PD Modification Application: MM 25-0353

The applicant is requesting a modification to the Planned Development to remove Auto Repair/Motor Vehicle – Neighborhood Serving as a prohibited use. A "Take 5" auto service repair station is proposed to be developed on the site.

10: ZC	10: ZONING TECHNICIAN, Development Services Department DATE: 02/09/2025				
REVIE	REVIEWER: James Ratliff, AICP, PTP, Principal Planner AGENCY/DEPT: Transportation				
PLAN	NING SECTOR/AREA: RV/ Central	PETITION NO: MM	I 25-0353		
	This agency has no comments.				
	This agency has no objection.				
X	This agency has no objection, subject to listed or a	ttached conditions.			
	This agency objects, based on the listed or attached	l conditions.

8.2 Proposed Site Plan (Full)

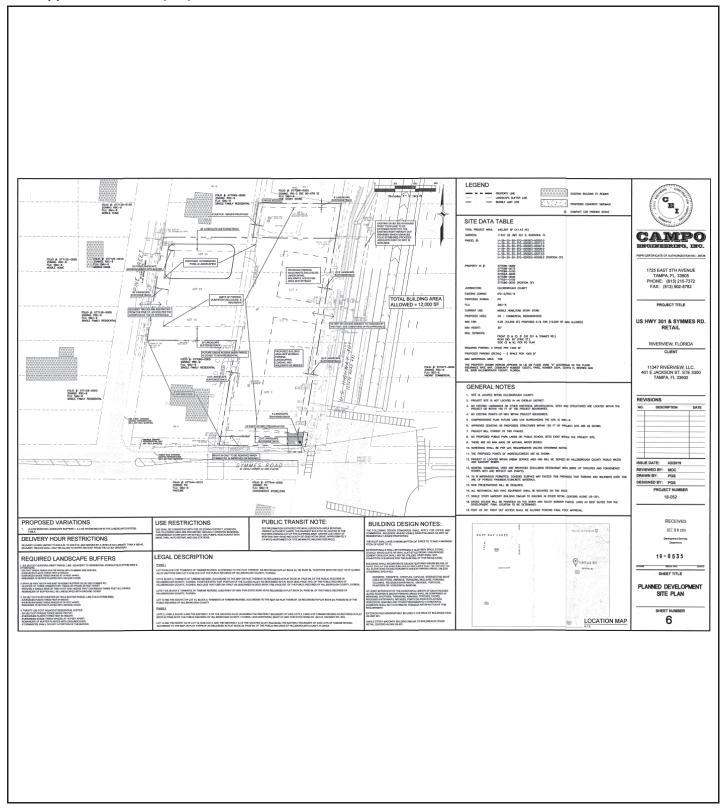
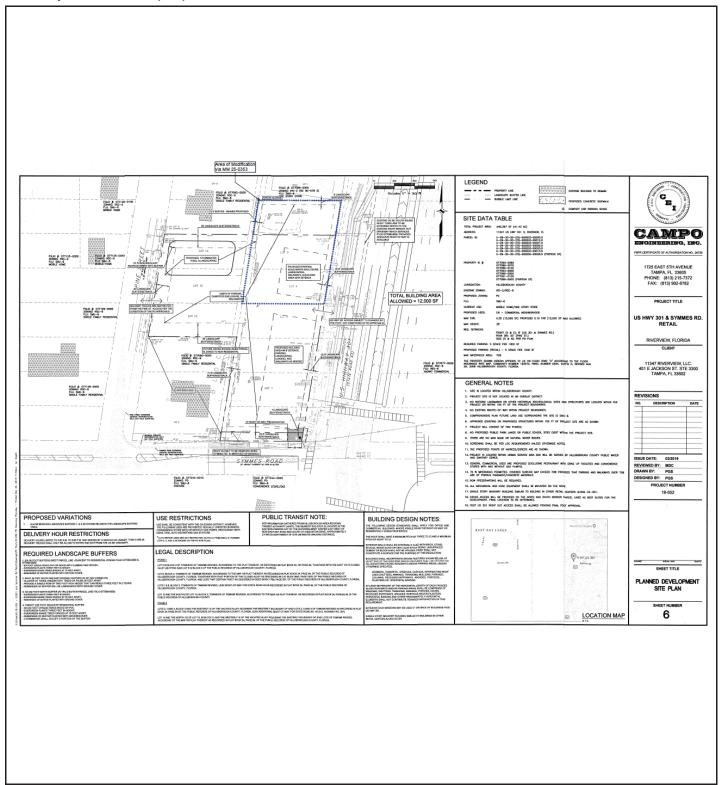
Staff notes that the above condition did not match the use restrictions contained on the PD site plan, which stated:

The applicant is seeking to modify a portion of the PD to allow auto-repair uses within the modification area (i.e. within folio 77089.0000, labeled as former lots 2, 3 and 4 as shown on the PD site plan).

Approval - Approval of the request, subject to the conditions listed below, is based on the general site plan submitted January 21st, 2025.

PINE STREET TYPICAL SECTION

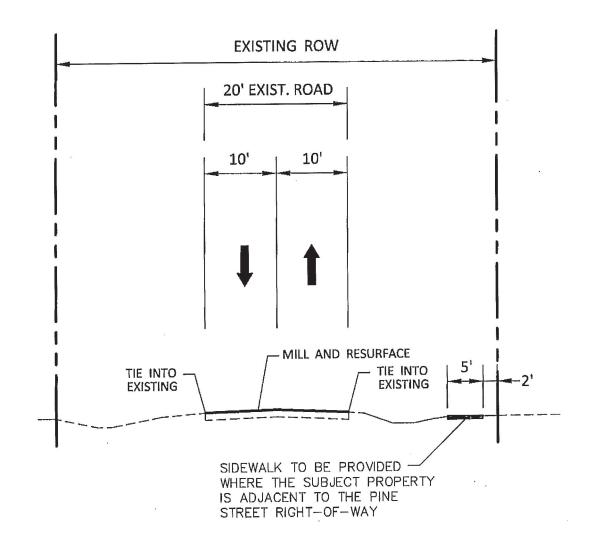
The purpose of this letter is to request a Design Exception to Section 6.04.03L of the Hillsborough County Land Development for Pine Street from the project access to Symmes Road. The project is located west of US 301 and north of Symmes Road. The developer proposes to rezone the property to Planned Development to allow the following uses:

- Lane Width TS-7 has 12' lanes. As shown in Table 1, the existing lanes are 10'.
 The Typical Section proposes to maintain the existing lane width and overlay the roadway with 1" of asphalt.
- 2. Shoulder TS-7 has 8' shoulders with 5' paved. This section proposes to maintain the existing shoulders.
- 3. Sidewalk TS-7 has sidewalk on both sides of the road. The proposed section does provide sidewalk on the east side of the roadway where the project is adjacent to Pine Street.

The justification for the Design Exception is as follows:

Pine Street is a low volume roadway; 17 h hour trip ends.	AM peak hour trip ends and 13 PM peak
Based on the limited right of way and low traff Exception are reasonable.	ic volumes on the roadway the Design
Please do not hesitate to contact us if you have information. Best Regards, Steven J Henry President Lincks & Associates, Inc. P.E. #51555	any questions or require any additional
Based on the information provided by the ap	plicant, this request is:
Disapproved	
If there are any further questions or you need Benjamin Kniesley, P.E. at (813) 307-1758	d clarification, please contact
Date06/18/19	Cincoroly
The County Engineer has reviewed zoning modification application # 25-0353 and determined the changes	Sincerely, Michael J. Williams
	hour trip ends. Based on the limited right of way and low traff Exception are reasonable. Please do not hesitate to contact us if you have information. Best Regards, Steven J Henry President Lincks & Associates, Inc. P.E. #51555 Based on the information provided by the ap

- 6. The applicant requested a Design Exception for deviations from the TS-3 Typical Section for 2-lan undivided local urban roadways. If MM 25-0353 is approved, the County Engineer will approve a *de minimis* exception as set out in the Transportation Review staff comment sheet and Development Services Department staff report.

PINE STREET TYPICAL SECTION

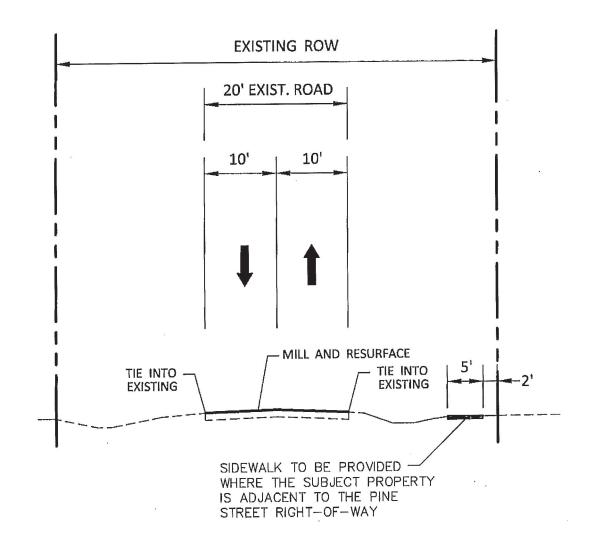
The purpose of this letter is to request a Design Exception to Section 6.04.03L of the Hillsborough County Land Development for Pine Street from the project access to Symmes Road. The project is located west of US 301 and north of Symmes Road. The developer proposes to rezone the property to Planned Development to allow the following uses:

- Lane Width TS-7 has 12' lanes. As shown in Table 1, the existing lanes are 10'.
 The Typical Section proposes to maintain the existing lane width and overlay the roadway with 1" of asphalt.
- 2. Shoulder TS-7 has 8' shoulders with 5' paved. This section proposes to maintain the existing shoulders.
- 3. Sidewalk TS-7 has sidewalk on both sides of the road. The proposed section does provide sidewalk on the east side of the roadway where the project is adjacent to Pine Street.

The justification for the Design Exception is as follows:

Pine Street is a low volume roadway; 17 hour trip ends.	AM peak nour trip ends and 13 PM peak
Based on the limited right of way and low traff Exception are reasonable.	fic volumes on the roadway the Design
Please do not hesitate to contact us if you have information. Best Regards, Steven J Henry President Lincks & Associates, Inc. P.E. #51555	any questions or require any additional
Based on the information provided by the ap	oplicant, this request is:
Disapproved	
If there are any further questions or you nee Benjamin Kniesley, P.E. at (813) 307-1758	d clarification, please contact
Date06/18/19	
	Sincerely,
The County Engineer has reviewed zoning modification application # 25-0353 and determined the changes	Michael J. Williams
